STAFF REPORT
(Preliminary Plat)

CASE NUMBER: S/D 00-15 -- HIGHLAND SPRINGS COMMERCIAL ADDITION

STAFF REPORT
(Final Plat, Preliminary Plat Approved 2/17/00)

CASE NUMBER: S/D 00-15 -- HIGHLAND SPRINGS COMMERCIAL ADDITION

VICINITY MAP

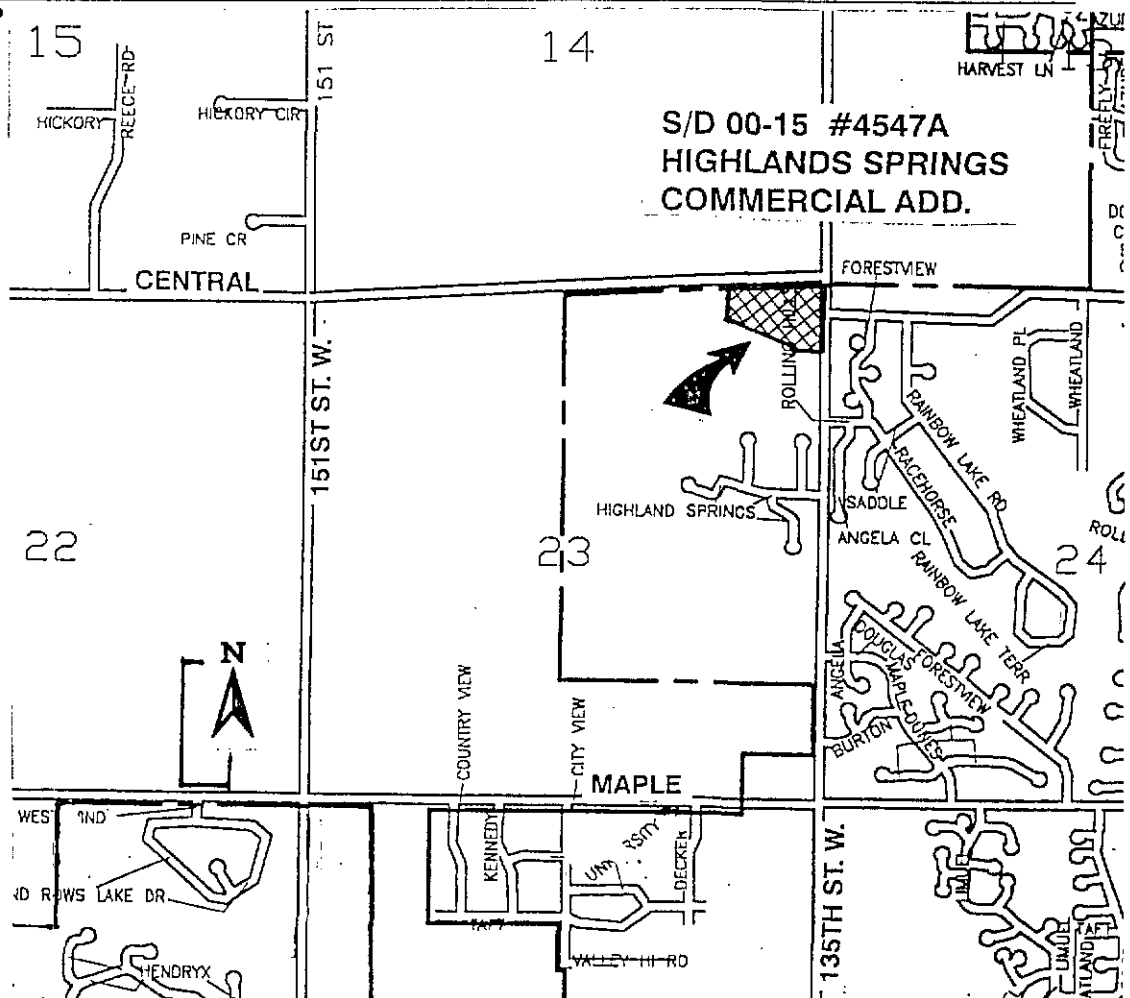
- A. The Applicant shall guarantee the extension of sanitary sewer and City water to serve the lots being platted. City Engineering needs to comment on the need for additional guarantees or easements.

- C. City Engineering needs to comment on the status of the applicant's drainage plan.
- D. Traffic Engineering needs to comment on the access controls. The plat proposes three access openings along the south side of Central, including two joint openings. On the north side of Central two access openings are proposed, including one joint opening. Along 135th St. West, the plat proposes one access opening north of Central and two openings south of Central. Distances should be shown for all segments of access control. In accordance with the Subdivision regulations, any access openings located within 250 feet of the intersection of Central and 135th St. West are limited to right-turns only, and shall be referenced on the face of the plat; or a guarantee provided for the future construction of a raised medial. The final plat shall reference the access controls in the plat's text.

- E. Traffic Engineering needs to comment on the need for street improvements. The CUP required the following: a) a guarantee for the construction of Central to three lanes between 135th St. West and where the realigned street meets the present location of Central and b) construction of a three lane roadway between the south line of Lot 4 and the north line of Lot 2 along 135th St. West.

- F. A temporary road easement for Central Avenue will need to be established by separate instrument until the improvements to the new alignment of Central are completed.

- G. The joint access openings need to be established by separate instrument.
- H. A cross-lot circulation agreement shall be provided between the non-residential lots.

- I. The wall easement should be referenced on the final plat.
- J. Provisions shall be made for ownership and maintenance of the proposed reserves. The applicant shall either form a lot owners' association prior to recording the plat or shall submit a covenant stating when the association will be formed, when the reserves will be deeded to the association and who is to own and maintain the reserves prior to the association taking over those responsibilities.

- M. Documentation must be provided that the pipeline easement as indicated on the platting binder has been released. If the easement has been confined, proof needs to be provided that it does not in any way encroach this site. If the easement does impact this site, it shall be shown and subject to the standard pipeline conditions.

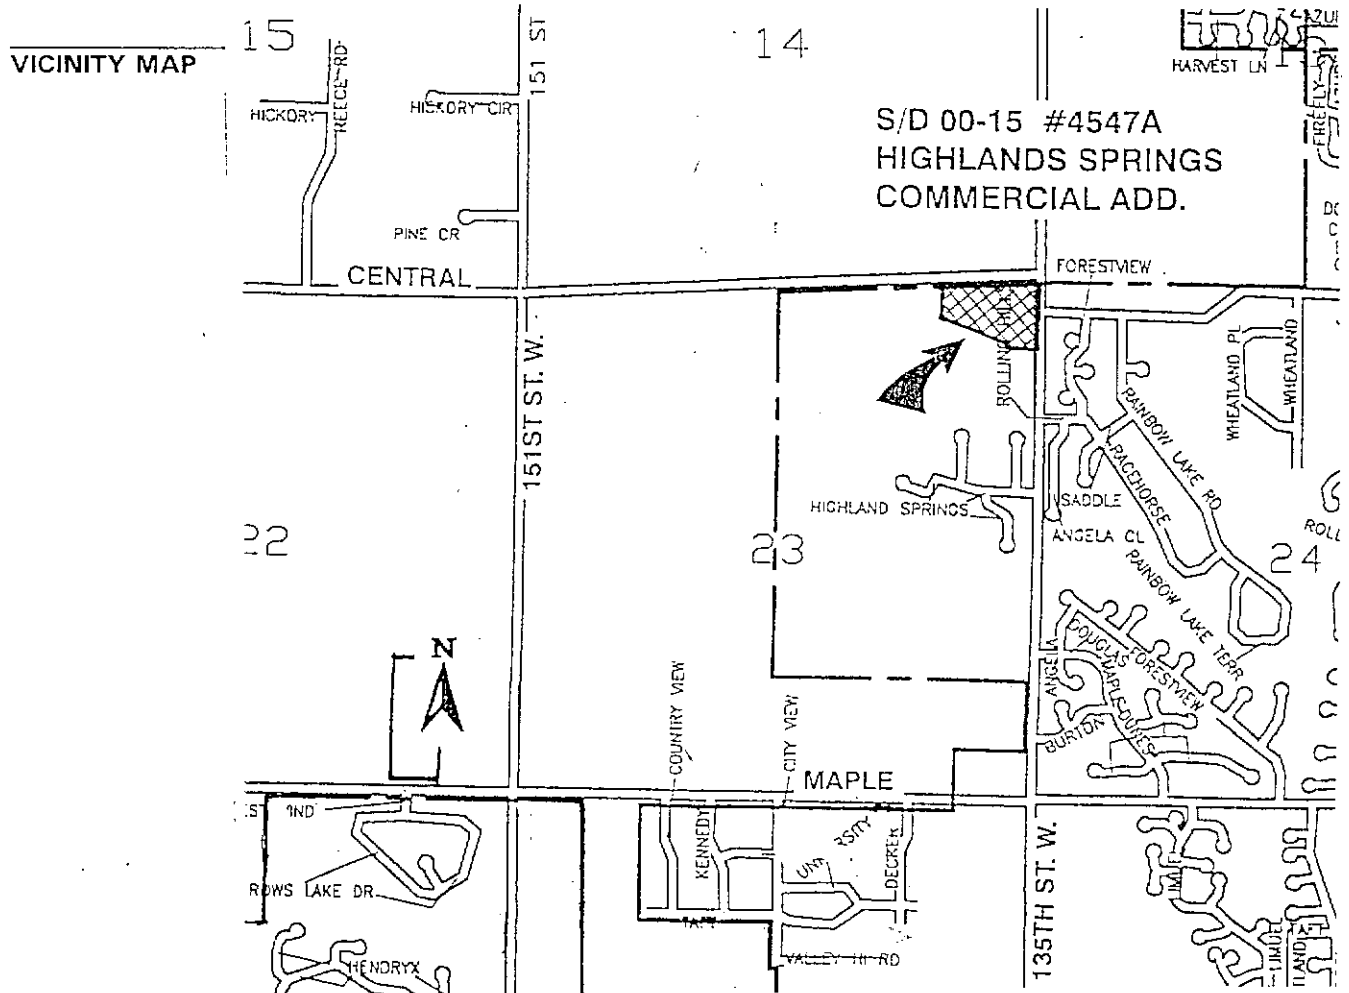
- C. City Engineering needs to comment on the status of the applicant's drainage plan. A drainage easement is required.
- D. The definite location of the KGE temporary easement needs to be provided on the plat.

- E. Traffic Engineering needs to comment on the access controls. The plat proposes three access openings along the south side of Central, including two joint openings. On the north side of Central two access openings are proposed, including one joint opening. Along 135th St. West, the plat proposes one access opening north of Central and two openings south of Central. For Lot 2, 150 feet of complete access control is required along 135th St. Distances should be shown for all segments of access control. In accordance with the Subdivision regulations, any access openings located within 250 feet of the intersection of Central and 135th St. West are limited to right-turns only, and shall be referenced on the face of the plat; or a guarantee provided for the future construction of a raised medial. The final plat shall reference the access controls in the platting text.

- F. Traffic Engineering needs to comment on the need for street improvements. The CUP required the following: a) a guarantee for the construction of Central to three lanes between 135th St. West and where the realigned street meets the present location of Central and b) construction of a three lane roadway between the south line of Lot 4 and the north line of Lot 2 along 135th St. West.

- G. A temporary road easement for Central Avenue will need to be established by separate instrument until the improvements to the new alignment of Central are completed.

- H. The joint access openings need to be established by separate instrument.
- I. A cross-lot circulation agreement shall be provided between the non-residential lots.

- T. The representatives from the utility companies should be prepared to comment on the need for any additional utility easements to be platted on this property. KGE requests a temporary easement to cover their line until Central is realigned. KGE and Southwestern Bell have requested additional easements.
